Hākitekura Redevelopment – Academic Retreat and Conference Facility

Land Use Consent Application (RM200570)
to the Queenstown Lakes District Council

Section 92 Response – Part 1

Figure 1: Overspill Parking Location

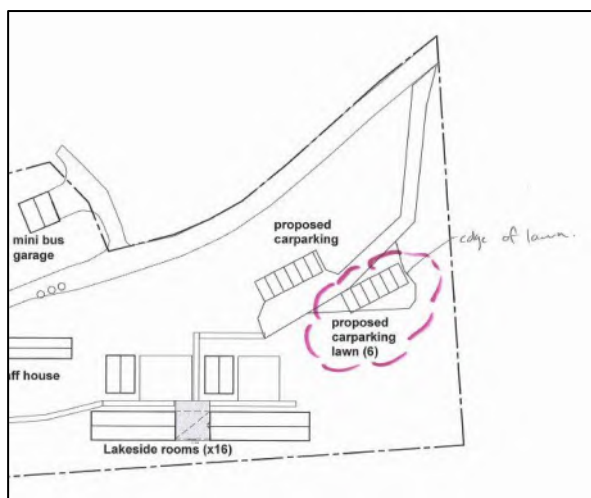
Please clarify the location and number of parking spaces within the parking overflow area and the likelihood that these spaces will be utilised to determine the full extent of the parking shortfall.

Figure 1 shows the intended location of the overspill parking area (extracted from the Parking Plan (drawing 10-03c) prepared by Kerr Ritchie and attached to Part 1 of the overarching s92 response).

upon the extent of usage, this parking could be made semi-permanent with the use of Grasscrete pervious pavers or similar.

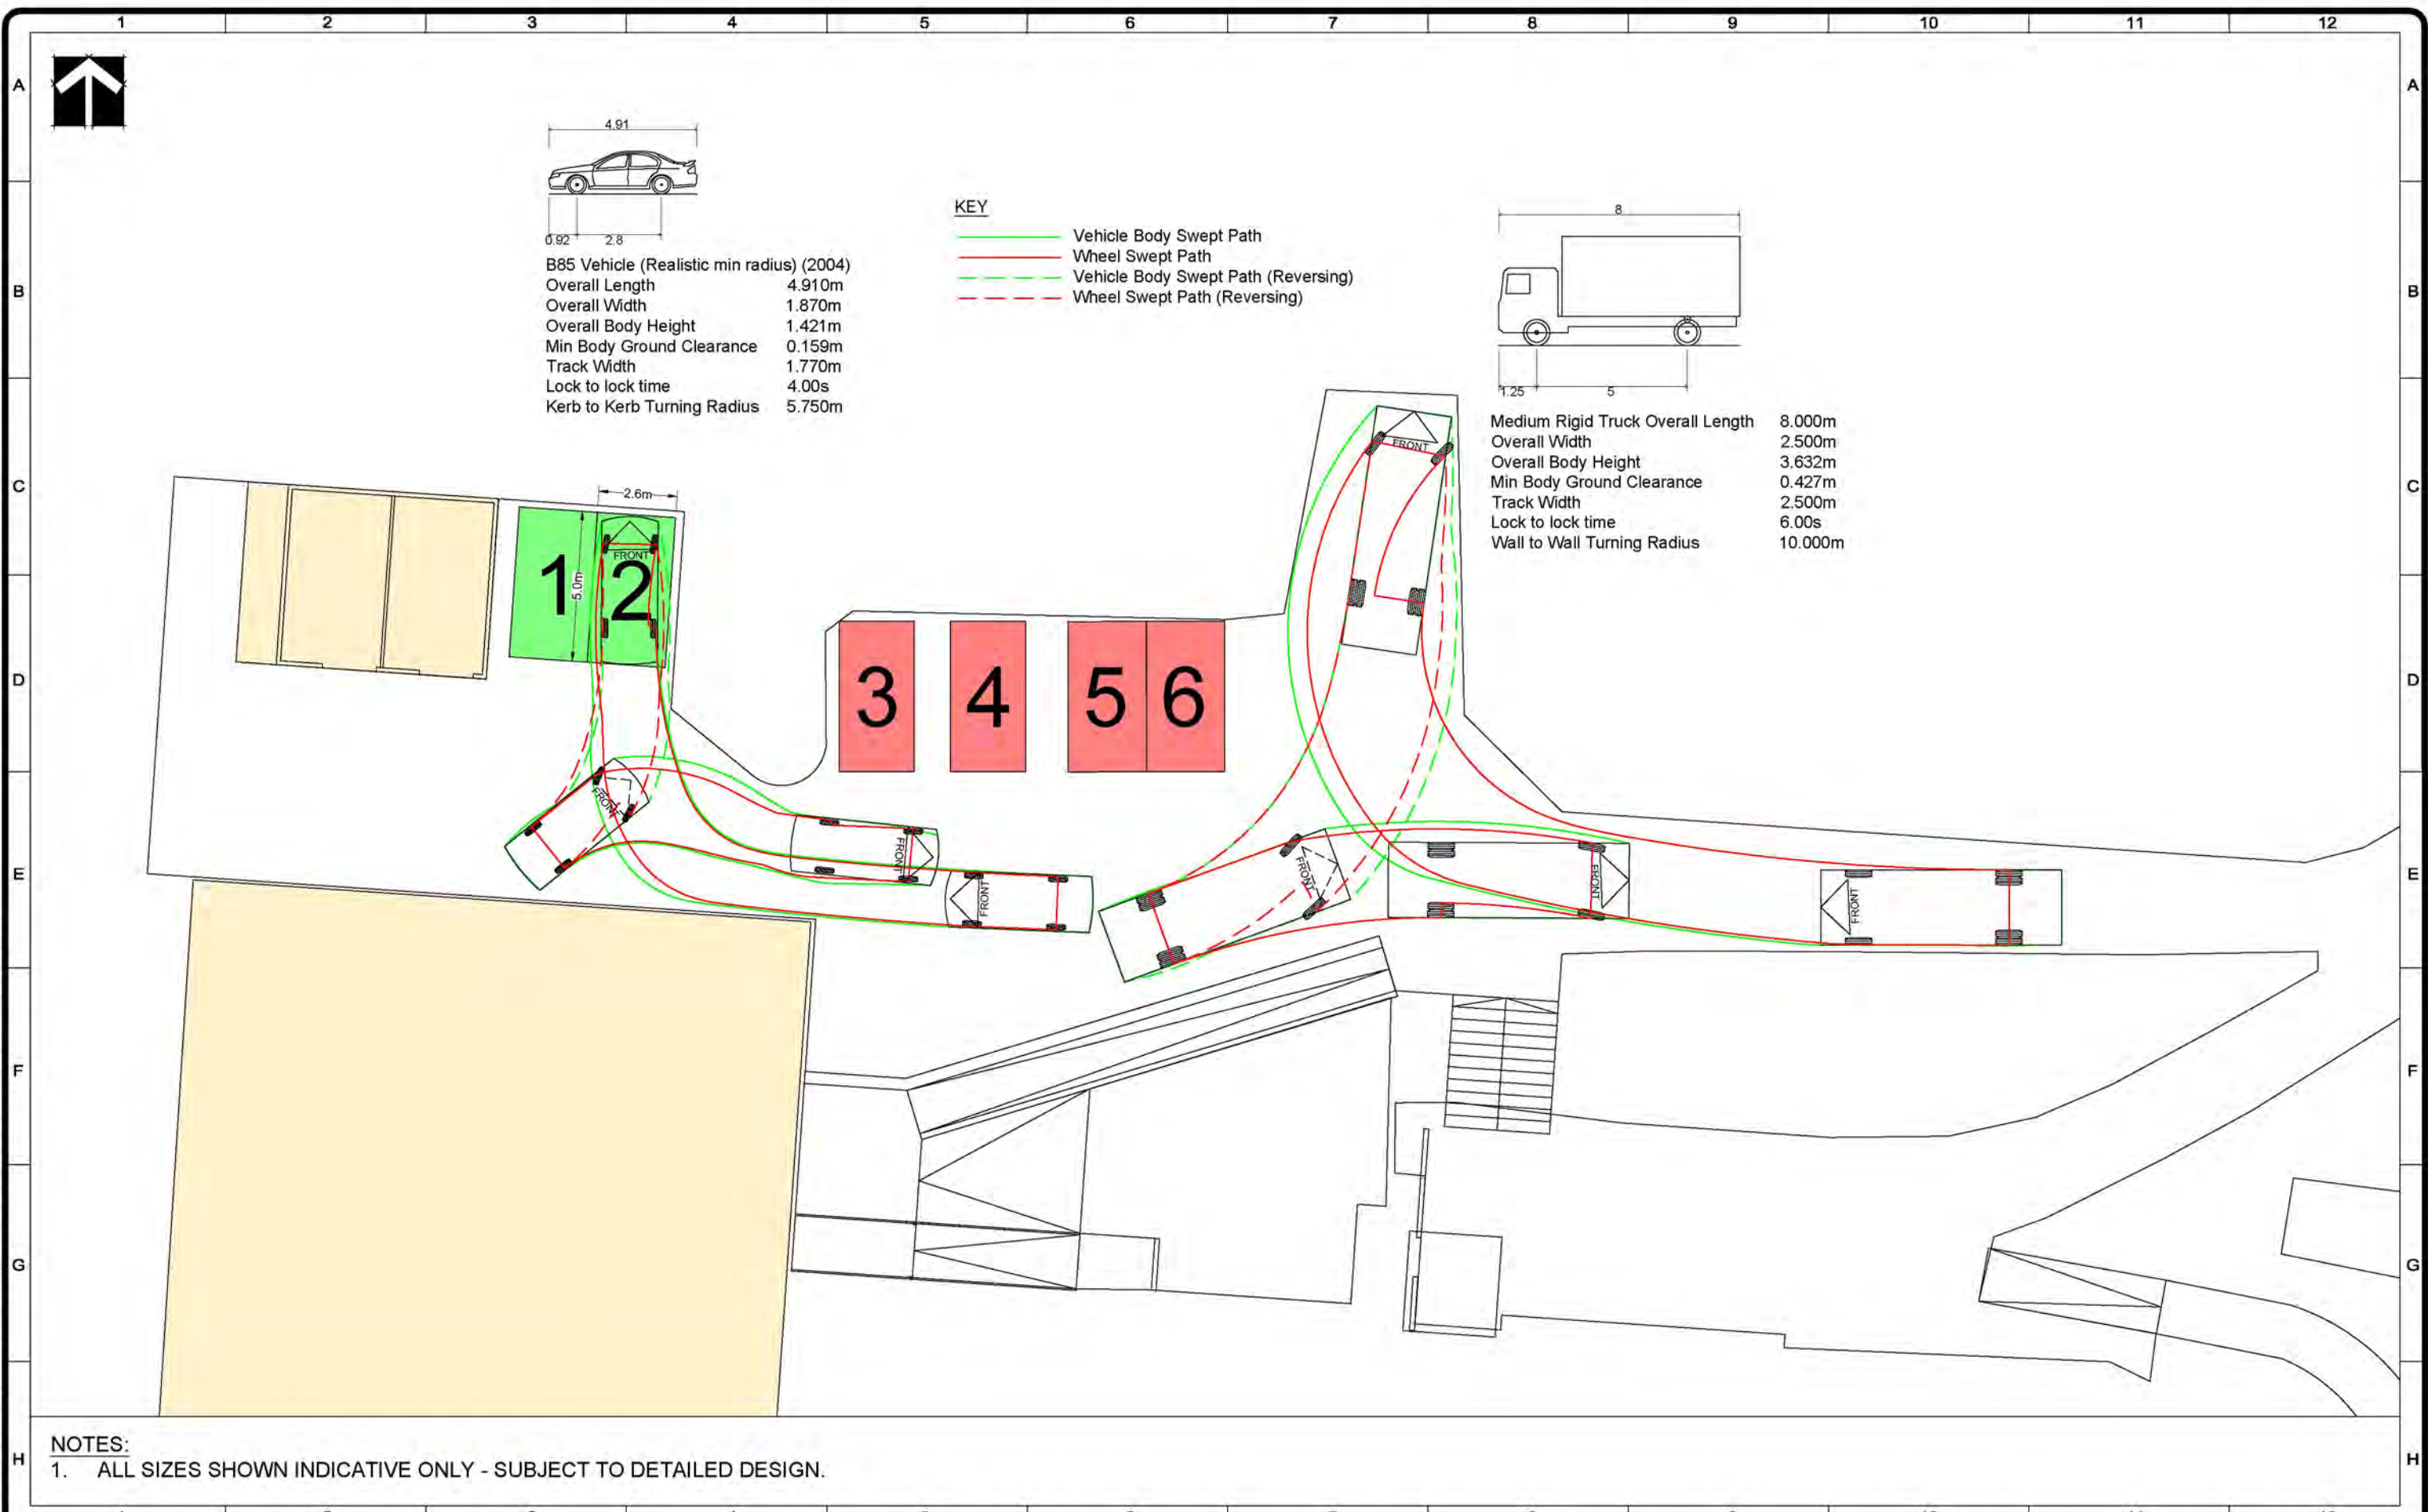
- a) Where parking spaces are in the immediate vicinity of circulation roadways please provide swept path diagrams.***
- b) The ITA states a manoeuvring area will be provided adjacent to the Woolshed building to enable minivans / taxis to turn around when dropping off or collecting passengers. This will also enable service vehicles to turn around. Please confirm where this location is an annotate it on the site plan and please provide swept path diagrams for a larger service vehicle (8m truck) manoeuvring into and out of the service area for loading/unloading.***

In regard to item 16b) we have added annotation to the Car Parking Layout plan sheet 010 indicating where the service vehicle turning area is proposed to be located. The Vehicle Manoeuvring Diagram plan sheet 011 also includes the vehicle wheel tracks and swept path diagram for an 8m rigid truck entering and exiting this area.
